[Federal Register: October 24, 2002 (Volume 67, Number 206)]
[Rules and Regulations]
[Page 65290-65298]
From the Federal Register Online via GPO Access [wais.access.gpo.gov]
[DOCID:fr24oc02-2]

[Docket No. 2000-CE-44-AD; Amendment 39-12920; AD 2002-21-13]

Airworthiness Directives; Raytheon Aircraft Company Beech Models 35, 35R, A35, and B35 Airplanes

ACTION: Final rule.

Figure 1

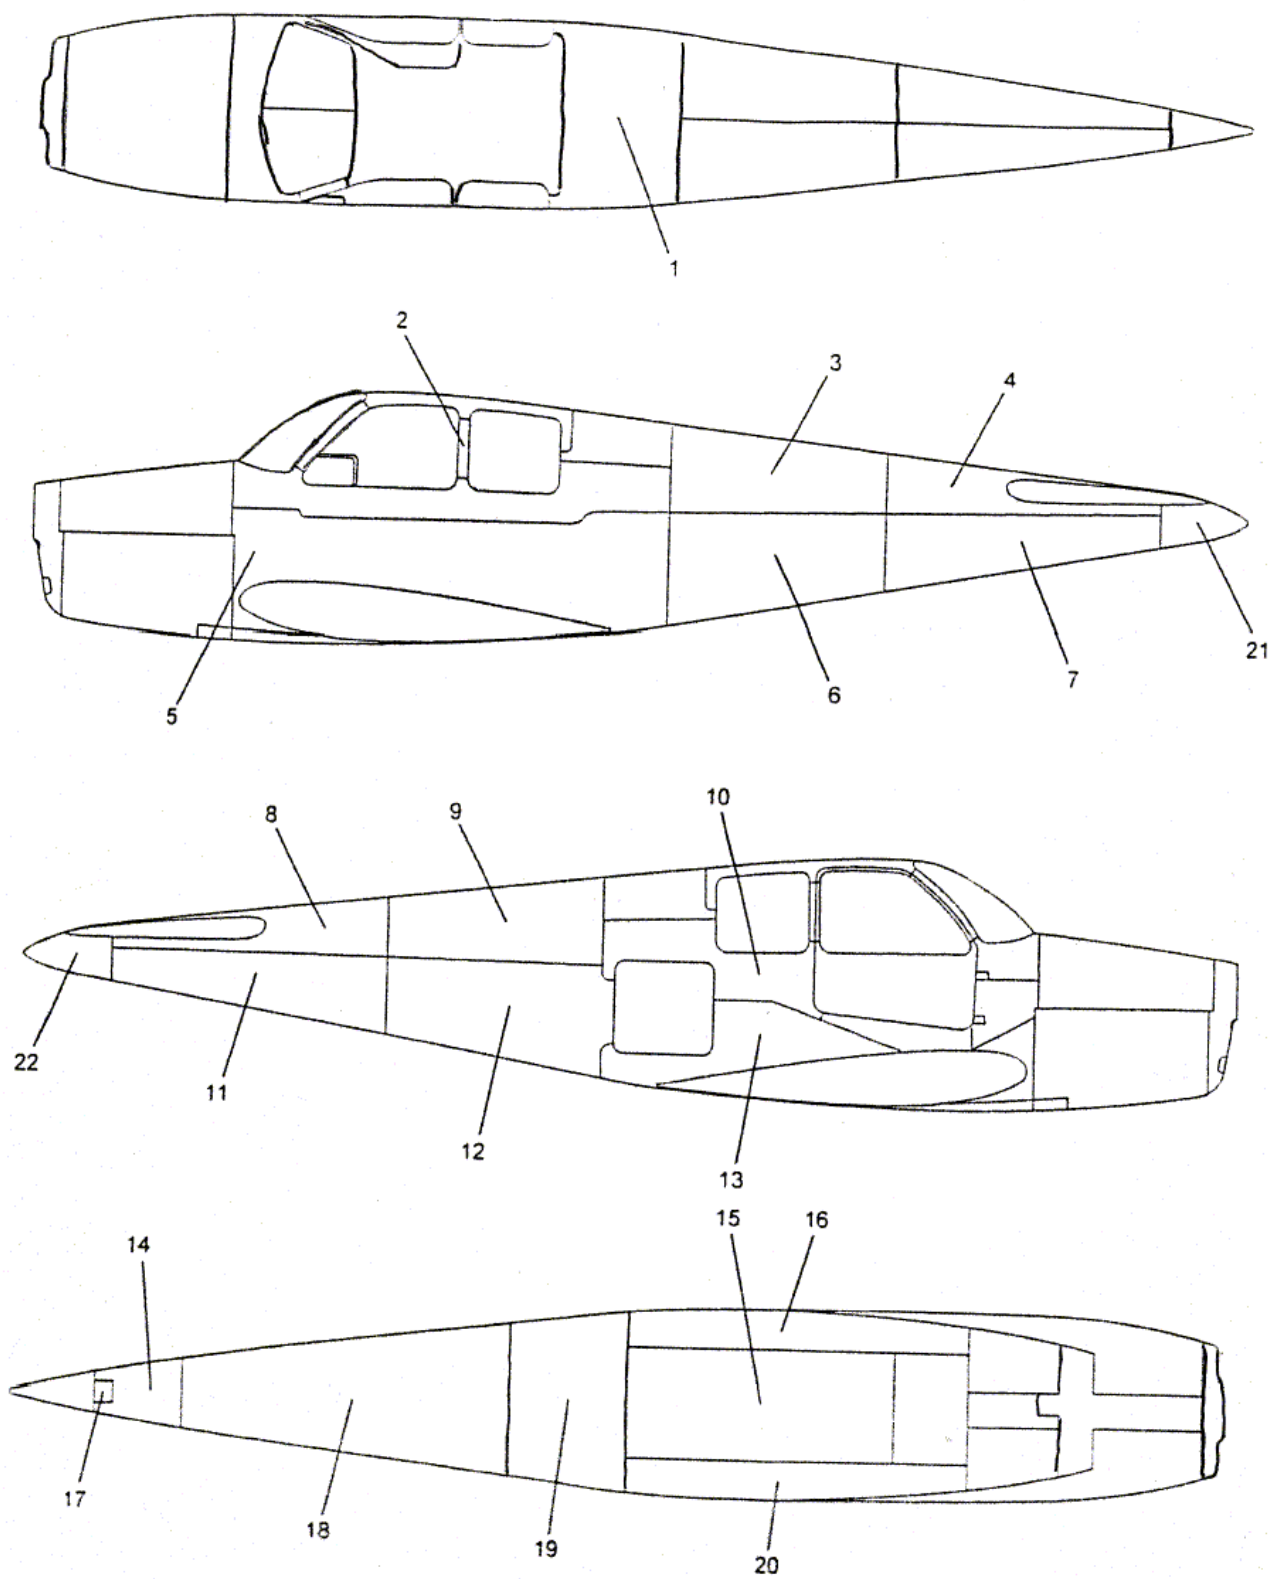
Several commenters present the same concern with the equipment used to measure skin thickness as that concern with the propeller balancing. That concern is specifying only one piece of equipment. These same commenters also state that there are differences in skin thickness, e.g., 0.016 inch instead of 0.018 inch.

We also concur that there are differences in skin thickness. We are adding to the final rule AD action reference to the different skin thicknesses that are specific to each airplane serial number and the location (fuselage stations) of each affected skin part number.

(5) Visually inspect the empennage, aft fuselage, and ruddervator control system for damage: (i) Part of this is an inspection of the aft fuselage skin for wrinkles or cracks. Specific skin thicknesses are presented in Figures 1 and 2 of this AD. The skin thickness measurement is not repetitive. (ii) The inspection and setting of the travels on the elevator and elevator trim tabs are not repetitive. (iii) Repair or replace any damaged parts and set the elevator controls, rudder and tab system controls, cable tensions, and rigging.	Inspect within the next 100 hours TIS after the last inspection required by AD 94-20-04 or within the next 25 hours TIS after December 10, 2002 (the effective date of this AD), whichever occurs later, and thereafter at intervals not to exceed 100 hours TIS, except for the skin thickness measurement and the inspection and setting of the travels on the elevator and elevator trim tabs, which are one-time actions. Accomplish any repairs, replacements, and adjustments prior to further flight after the applicable inspection.	Accomplish the inspection and repairs or replacements in accordance with the procedures in paragraphs (5)(a) through (5)(f) of the ACCOMPLISHMENT INSTRUCTIONS section of Raytheon Service Bulletin No. SB 27-3358, Issued: February, 2000, and use a digital ultrasonic skin tester or equivalent skin tester or direct methods that utilize calipers and micrometers. Specific skin thicknesses are contained in Figures 1 and 2 of this AD.
